# Technical Service Bulletin

## 26 Chirping noise from rear of vehicle

26 17 32 2047565/2 May 16, 2017. Supersedes Technical Service Bulletin Group 26 number 17-31 dated April 18, 2017 for reasons listed below.

Model(s)	Year	VIN Range	Vehicle-Specific Equipment
R8	2016 - 2017	900001 - 904259	Not Applicable

**Figure 2.** Bracket for exhaust system.

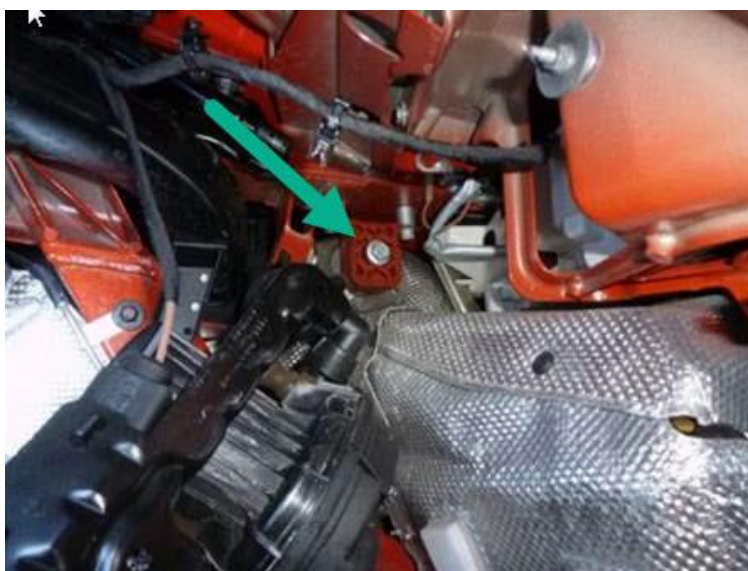
If the concern is caused by the washer, replace the washer on both sides of the muffler (Figure 2).

Modified washer. The new washer is coated on one side with graphite.

**Figure 3.** Washer.

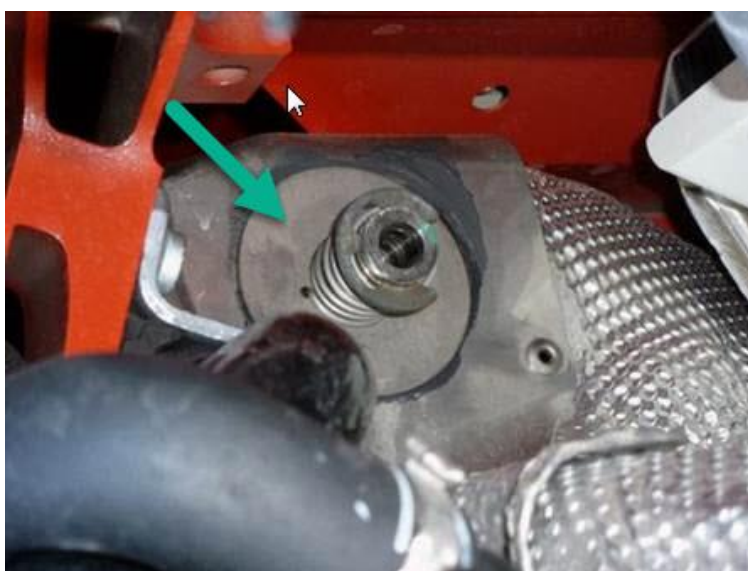
The graphite-coated side of the washer must face the heat shield (Figure 3).
